RE: Docket No. 20230114-WS - Application for certificates to provide water and

wastewater service in Volusia County, by Applegate Utility, LLC.

Re: Compliance Assistance Offer

FLORIDA DEPARTMENT OF ENVIRONMENTAL PROTECTION <u>WASTEWATER</u> COMPLIANCE INSPECTION REPORT

Photo DSC02397 – June 10, 2022 – 1:11 PM Photo taken by Gina Laddick

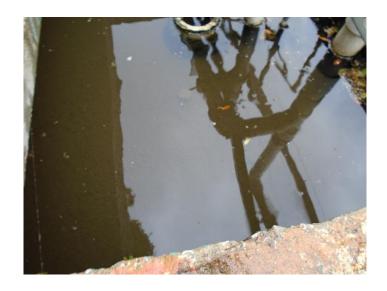
6.3 <u>Deficiency</u>: Solids were present in the clarifier effluent, in the chlorine contact chamber, and in the final effluent. See photos DSC02397, DSC02398, DSC02399, and DSC02400 in the attached photo log.

6.5 <u>Deficiency</u>: The clarifier has excessive grit and sand accumulation, causing an elevated sludge blanket. See photo DSC02398 in the attached photo log.

<u>Corrective Action:</u> Within 15 days of the date of this letter, remove the solids from each of the above referenced areas and provide documentation to the department that the corrective action has been completed.

<u>Corrective Action:</u> Clean the clarifier as needed and implement a plan to ensure the sludge blanket is maintained. Within 15 days of the date of this letter, provide documentation that the corrective action has been taken.
